## RANCHO MURIETA COMMUNITY SERVICES DISTRICT

### IMPROVEMENTS COMMITTEE

# MEMORANDUM

# MRK DEVELOPMENT, INC

Exhibit A  
Water

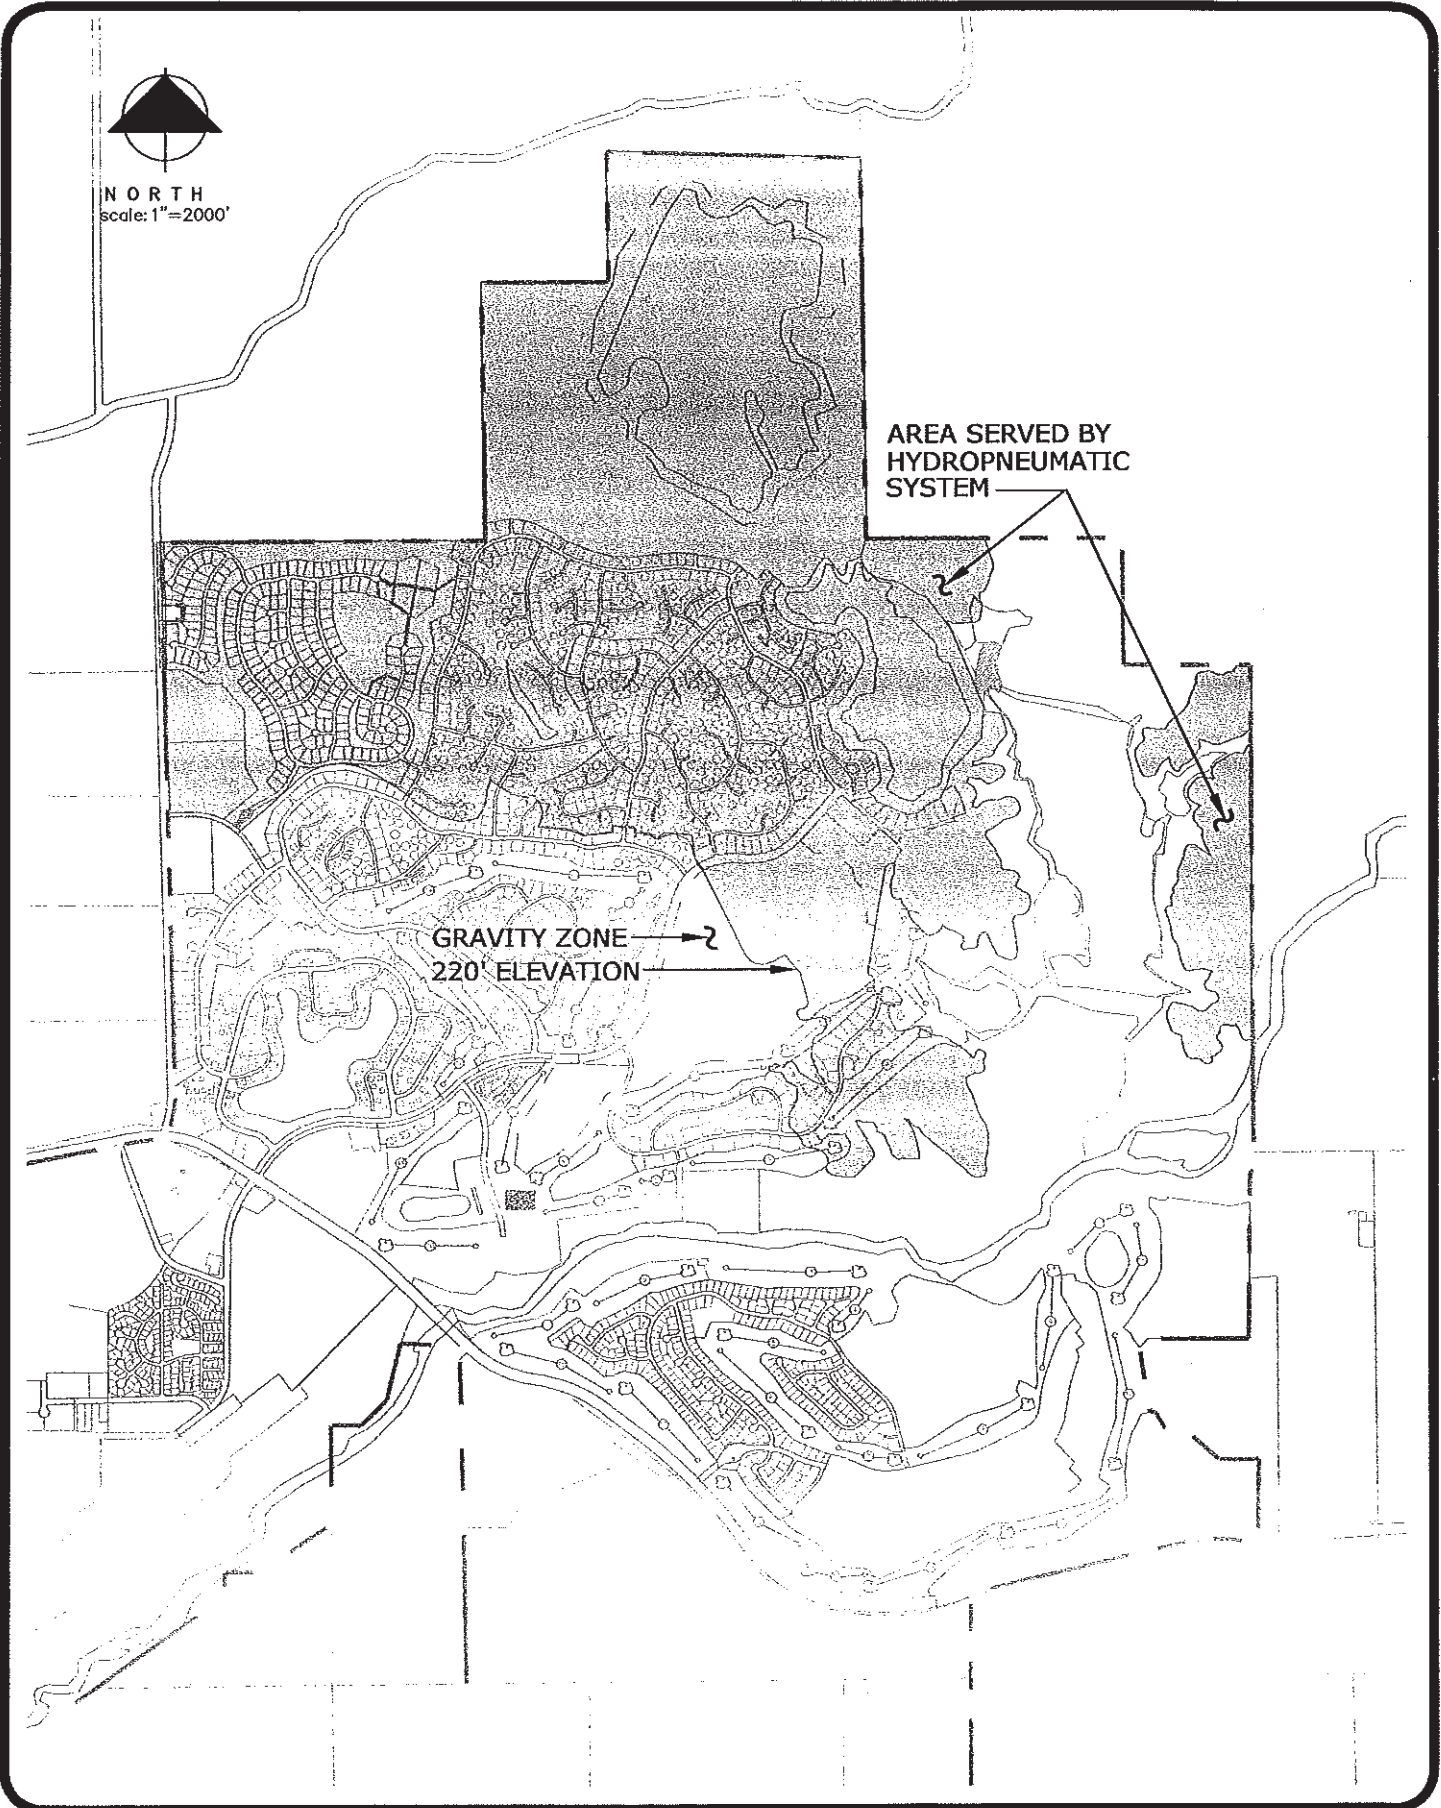
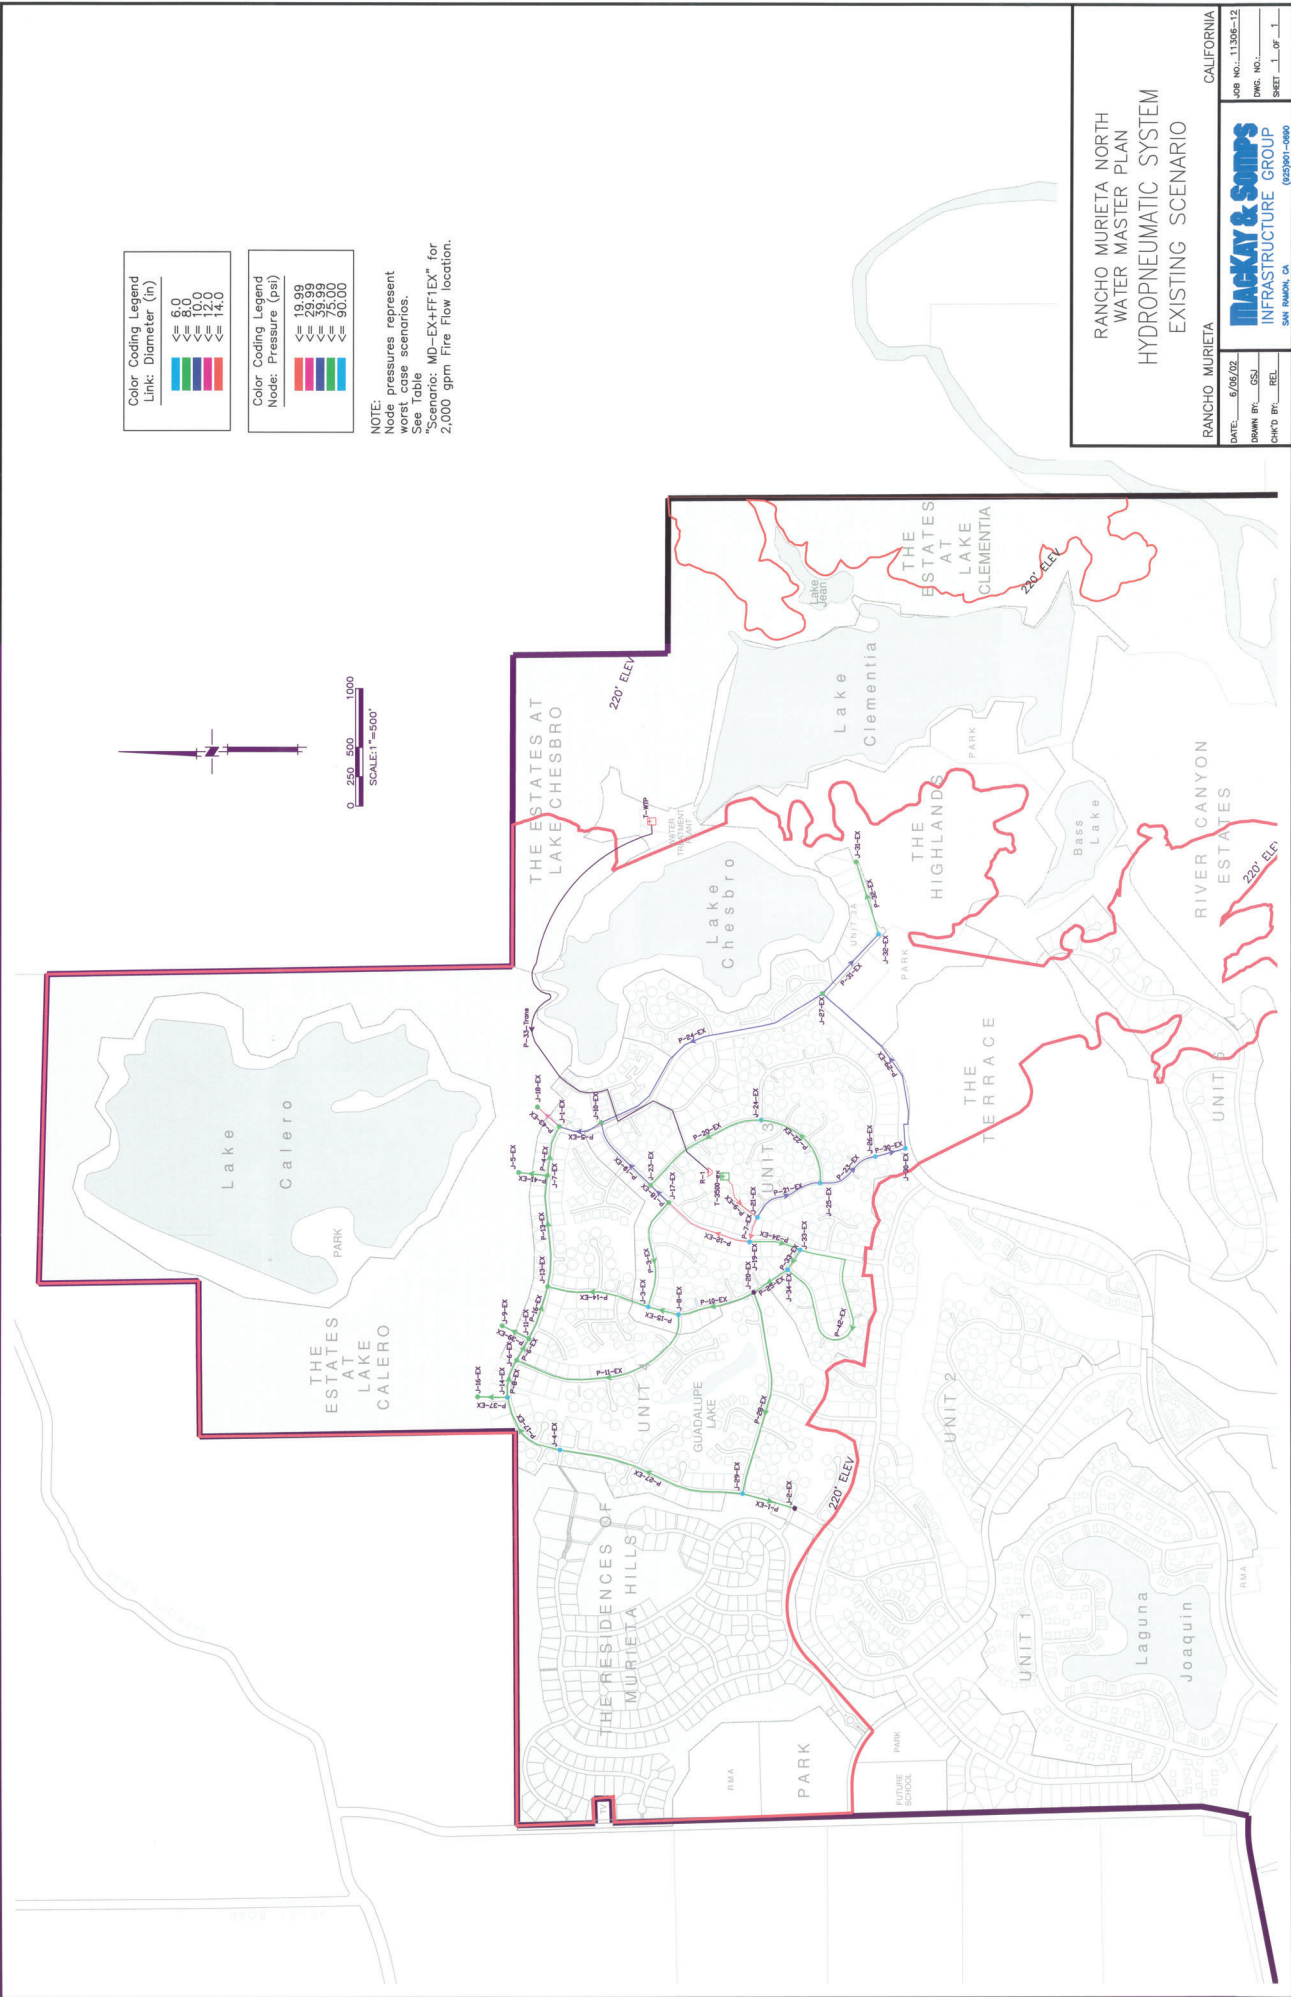
Water – According to Section II-Infrastructure Elements, Sub-section A-Water (Exhibit A), The results of the Water Model demonstrated that the existing Hydro-pneumatic pump system has the capacity to accommodate the demand of the Murieta Hills Development with adequate system pressures (including fire suppression). We would like to have you confirm these findings and confirm the connection points for the new development as marked on Exhibit B.

## Exhibit 7.1

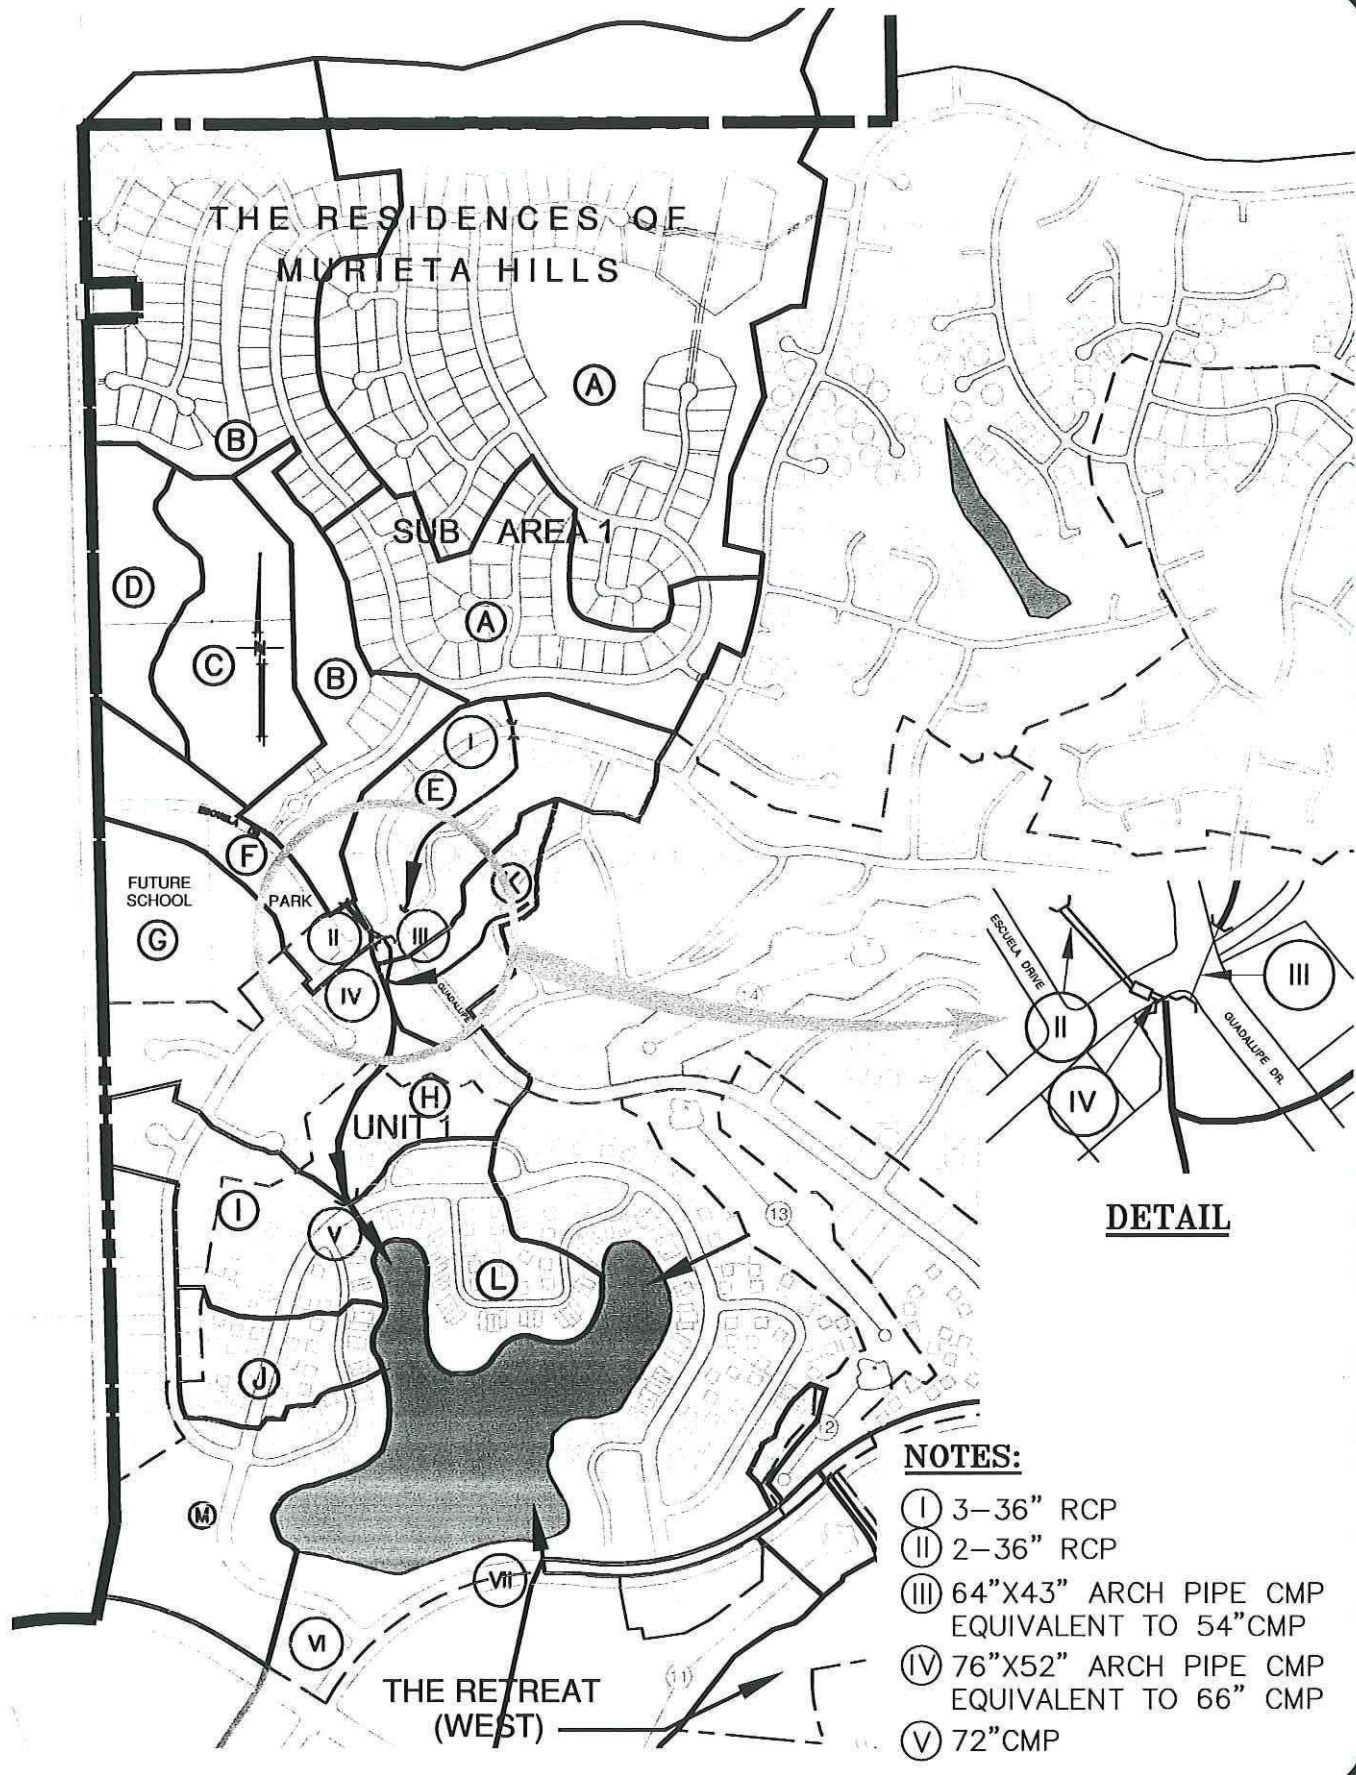
Drainage – Page 21 Infrastructure Elements sub-section “The Residences at Murieta Hills determines that the existing conveyance system can accommodate 100 year storm event. We would be building an on site detention basin designed to reduce post development peak flows to pre-development peak conditions. Please confirm that we are ok to use this design.
